ADDENDUM – 02

SUBJECT:
RYEB Project #5718A
Salem City BOE
SALEM HIGH SCHOOL STADIUM
NJDOE SP#: 4630-050-23-1000

SKETCH No.
SKE-1

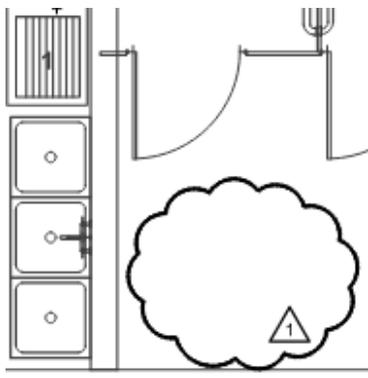
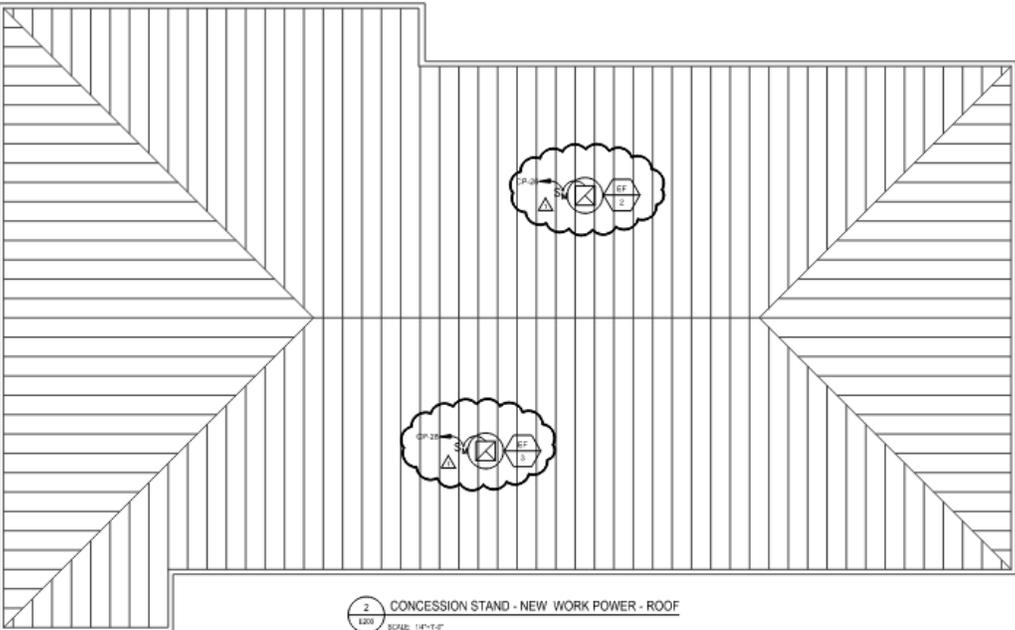
- 2.05. CHANGE: Details on shts E100 & E200 as indicated on the attached SKE-1.
- 2.06. The list of current plan holders and addenda can be found at www.ryebread.com under the “Bidding” tab.

DRAWING E100 REVISION NARRATIVE:
 1. ADDED "1" CONDUIT FOR TIMER CIRCUIT."
 2. CHANGED 2" CONDUIT TO 3" CONDUIT.

DRAWING E100 REVISION NARRATIVE:
 1. REVISED "FROM (N) PANEL "MDP" TO READ "TO (N) PANEL "LP" IN PRESSBOX."

DRAWING E200 REVISION NARRATIVE:
 1. DELETED LOCATION OF EF-3 FROM WOMEN 103 TO ROOF.

DRAWING E200 REVISION NARRATIVE:
 1. ADDED ROOF PLAN TO SHOW FINAL LOCATIONS FOR EF-2 AND EF-3.

DRAWING E200 REVISION NARRATIVE:
 1. DELETED PANEL 'LP' FROM SCHEDULE AND REVISED LOADS.
